VSP-33
December 18, 1981

VENDOR SERVICE PUBLICATION

To: All Piper Distributors and CORPAC's
Subject: Bendix Service Bulletins 611, 616, 617, 619

Part 1. Addition of moisture drains and sealing of vent screens in S-1200 Series Magneto Covers.

Figure 1. Location of Drain Holes

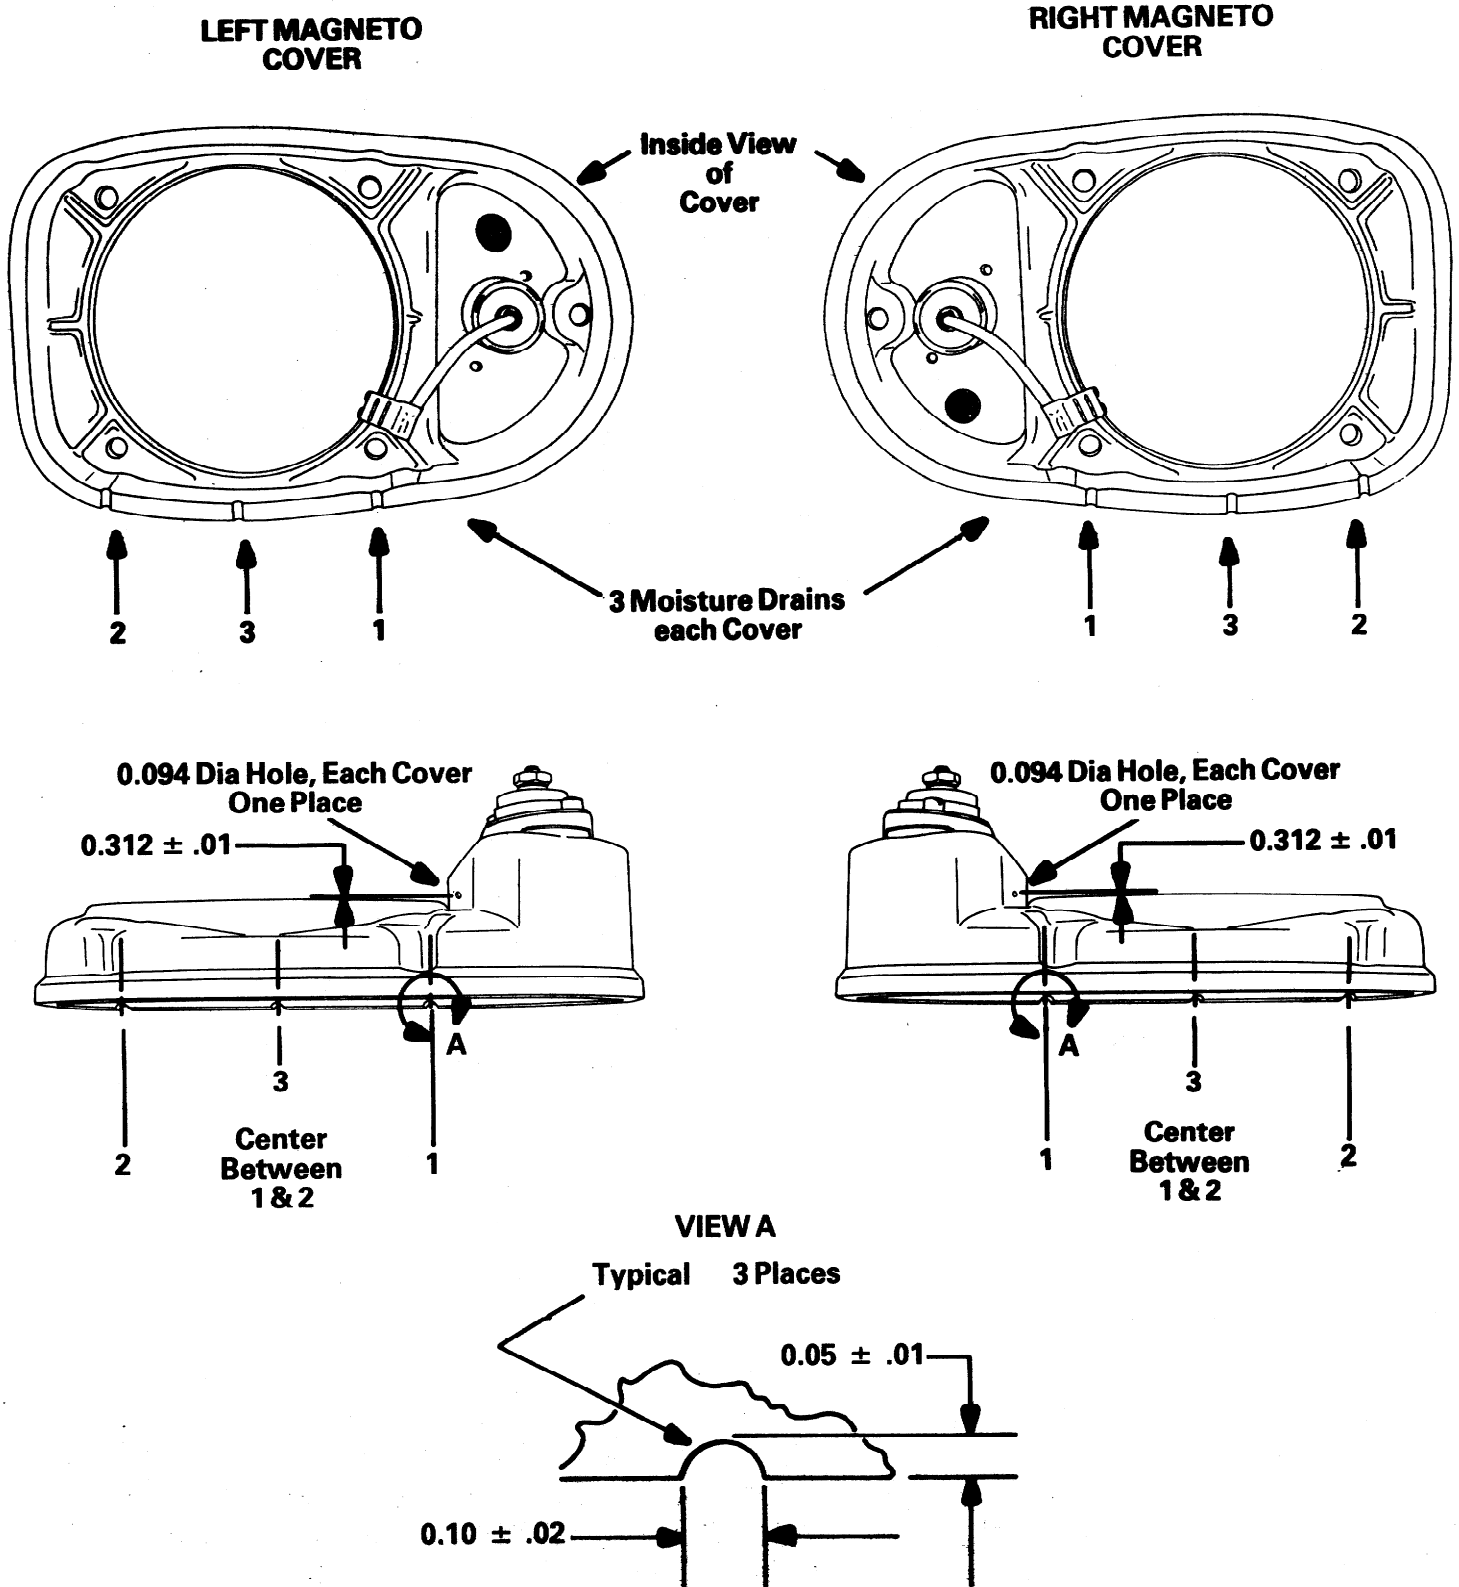
1. Remove the magneto cover by removing the ignition harness adapter plate from each magneto and then removing the magneto cover securing screw. Pull the magneto cover away from the magneto and carefully pull the capacitor, and retard lead, if used, from the breaker flag terminal(s).
2. Using Figure 1 as a guide, lay out the positions for the moisture drains. Positions 1 and 2 are in line with the stud holes in the cover and position 3 is centered between 1 and 2. Using a small round file, create the three hemispherical recesses as detailed in view A, figure 1.

The moisture drains must be on the lower side of each cover when it is reinstalled on its related magneto assembly on the engine.

3. Lay out the position for drilling a 0.094 in. \pm 0.005 in. hole in the center of the ledge area of the covers and drill one hole in each cover using a 3/32" or No. 42 drill, as shown in Figure 1.

Do not allow the drill to penetrate through the cover and hit the housing of the capacitor which is directly in line with the hole being drilled. Mask drill bit for maximum allowable depth (1/4 in.).

Figure 1. Exploded View

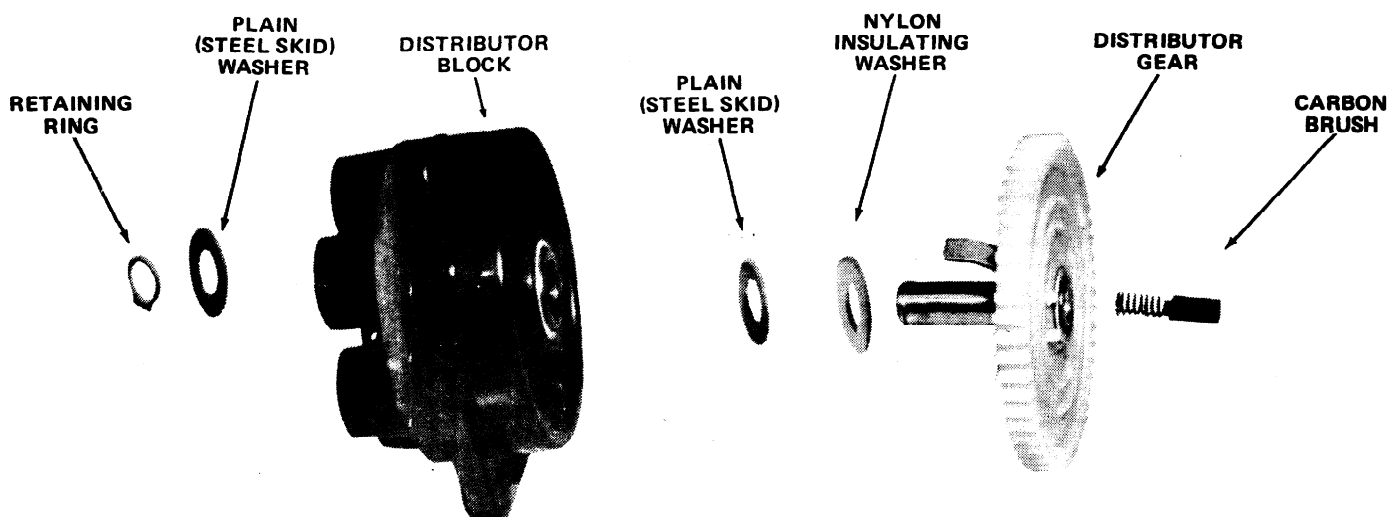
The 10-357584 and 10-357586 Insulated Distributor Gear Kits for S-20 and S-200 Series Magnetos are being provided as a standardization change for Bendix magnetos. With the introduction of these kits, all new Bendix aircraft magnetos delivered from the factory will be provided with insulated distributor gears. The insulated gear kits include all parts (except distributor block) as identified in figure 1.

Assembly sequence of the gear kit to distributor block is shown in the exploded view of figure 1.

Figure 1. Location of "x" on Identification Plate

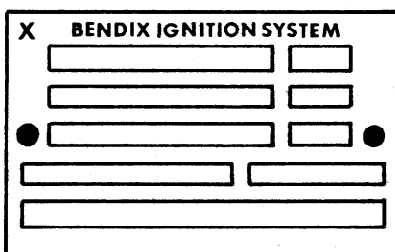
All D-2000/2200 series magnetos below serial number 35480 (red label magnetos) and below serial number 8122106 (blue label magnetos) unless identified with an "x" in the upper left corner of the identification plate before the word "Bendix" (see figure 1). The "x" on the identification plate indicates previous compliance.

6. If new serviceable gears, identified with the "z", the "x" and "o", or the "L" are installed in the magneto, identify the magneto by stamping the letter "x" in the upper left corner of the identification plate, before the word "Bendix" (see figure 1).

Figure 2. Location of Identification Mark(s)
on Distributor Gear

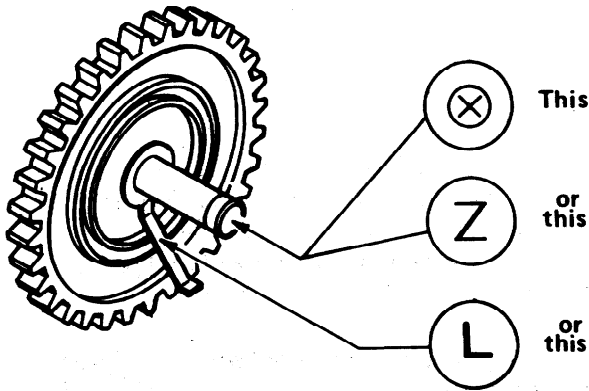
hours or at the next regularly scheduled inspection, whichever occurs first, and reinspected every 100 operating hours until the magneto has 500 operating hours. If the gears fail the inspection they must be replaced immediately with new, serviceable gears; if they pass each inspection they may remain in service until magneto overhaul, at which time they must be replaced with new, serviceable gears. At owner's option, gears that pass inspection may be replaced at any time during the compliance period with new, serviceable gears as identified in this paragraph and figure 2. Serviceable gears are identified by the presence of the letter "z" or the letters "x" and "o" appearing together, laser etched on the retaining ring end of the gear axle, or the letter "L" stamped on the electrode (see figure 2).

1. Remove cover from magneto and inspect the retaining ring end of the distributor gear axles for the letter "z" or the letters "x" and "o". (The letter "x" may or may not be circled by the letter "o".) If the letter "z" or the letters "x" and "o" together are laser etched on the end of the axles, the gears are serviceable and the cover can be reinstalled. Identify the magneto per

Figure 3. Checking for Loose Electrode

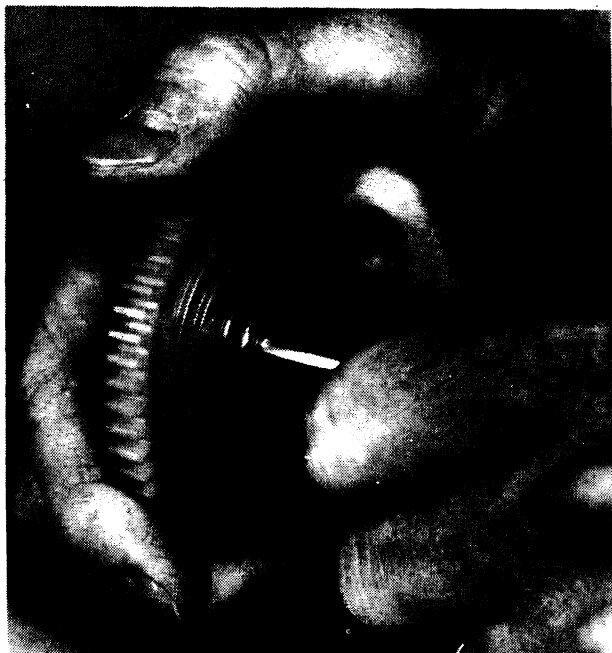
5. If the gear is the uninsulated type (no nylon washer) inspect the gear for a loose electrode. Grasp the gear firmly in one hand and alternately exert clockwise and counterclockwise force against the electrode with maximum hand pressure. This should be done in a manner that would attempt to pivot the electrode around the axle (see figure 3). If any movement is detected between the electrode and the gear, the gear must be discarded and replaced with a new, serviceable gear.

Figure 1. Location of "x" on Identification Plate

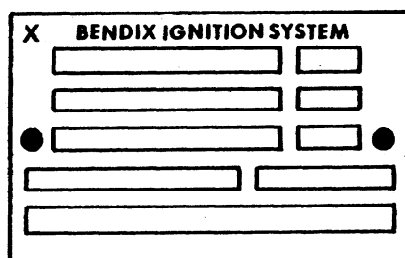
All D-3000/3200 Series (blue) Magnetos with Serial Numbers 100 through 1968 not identified by the letter "x" in the upper left corner of the identification plate (see figure 1). The "x" on the identification plate indicates previous compliance.

7. After the magneto has been reassembled with new serviceable gears, identify the magneto by stamping the letter "x" in the upper left corner of the identification plate, before the word "Bendix" (see figure 1).

Figure 2. Location of Identification Mark(s)
on Distributor Gear

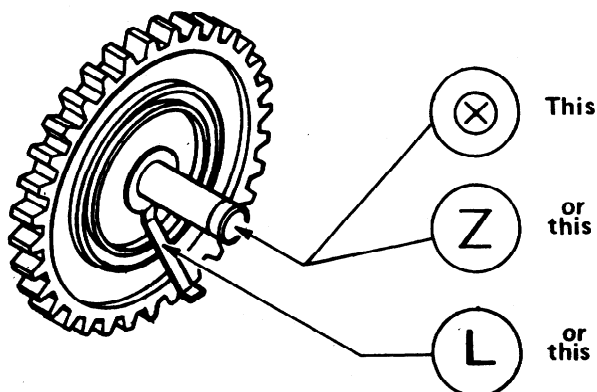
All distributor gear kits P/N 10-682014 and P/N 10-682016 which contain gears that are not identified by the presence of the letter "z" or the letters "x" and "o" together, laser etched on the retaining ring end of the gear axle, or the letter "L" stamped on the electrode (see figure 2).

5. Reassemble the distributor block with new serviceable gears. Serviceable gears are identified by the presence of the letter "z" or the letters "x" and "o" together, laser etched on the retaining ring end of the gear axle, or the letter "L" stamped on the electrode (see figure 2).
